CITY PLAN COMMISSION REPORT

Kinsley Forest Phase II

7 CD-CPC-2022-00044
Development Plan
(w/ preliminary plat)

Plan Conditions

STREAM BUFFER LEGEND

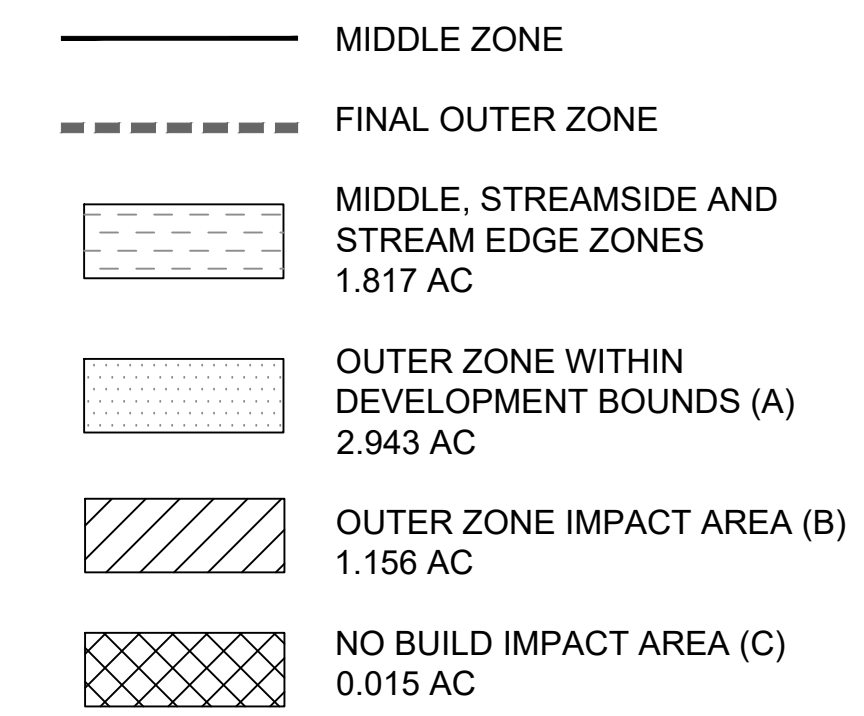
25. The developer shall submit a Preliminary Stream Buffer plan prior to approval of the plan in accordance with the Section 88-415 requirements.
26. The developer must show the limits of the 100-year floodplain plus the 1 foot freeboard on the final plat and show the Minimum Low Opening Elevation (MLOE) of any structure on each lot that abuts a 100-year flood prone area (including detention basins and engineered surface drainage conveyances) on any plat and plan, as required by the Land Development Division.

21. The developer shall submit a final stream buffer plan to the Land Development Division for approval prior to issuance of any building permits and obtain permits for the Stream Buffer prior to removal of any mature riparian species within the buffer zones due to construction activities on the site, in accordance with the Section 88-415 requirements.

3 EAST BUILDING - EAST ELEVATION
1/16" = 1'-0"

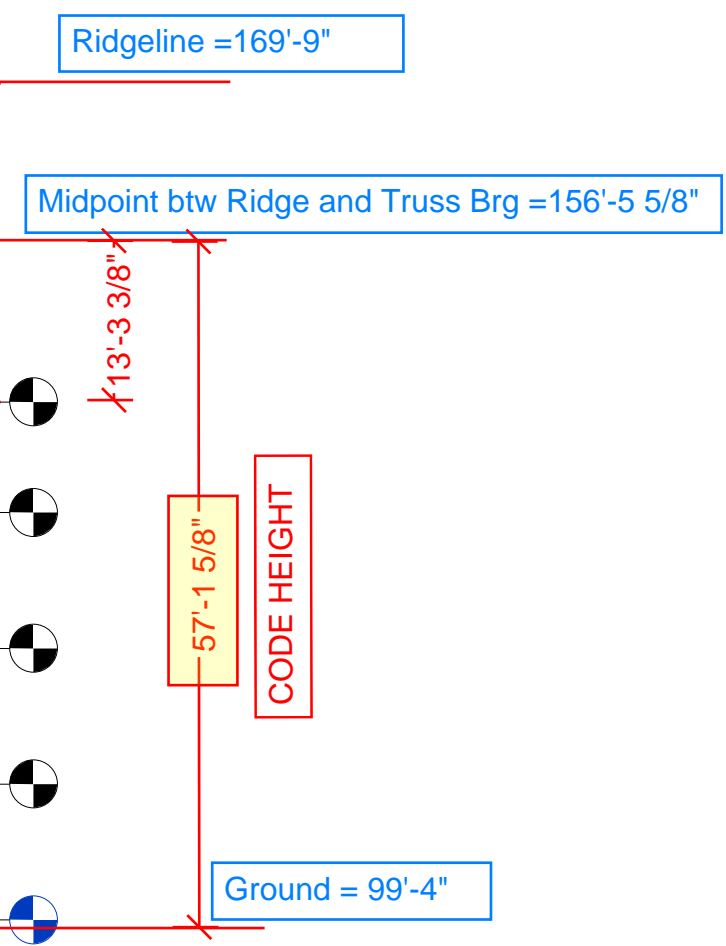
East building is requesting a 13' building height deviation to allow for a 58' tall building.

The deviations are necessary to construct a roof pitch that matches the architectural characteristics of the adjacent built environment. The building height also allows for a four-story building and without the deviations the applicant would only be able to construct a two-story structure which would drastically reduce the amount of dwelling units.

5. Comply with 88-425-08 and screen all dumpsters and utility equipment.
6. The applicant shall obtain the approval of three (3) deviations, one for each proposed building that exceeds the maximum building height of 45 feet.
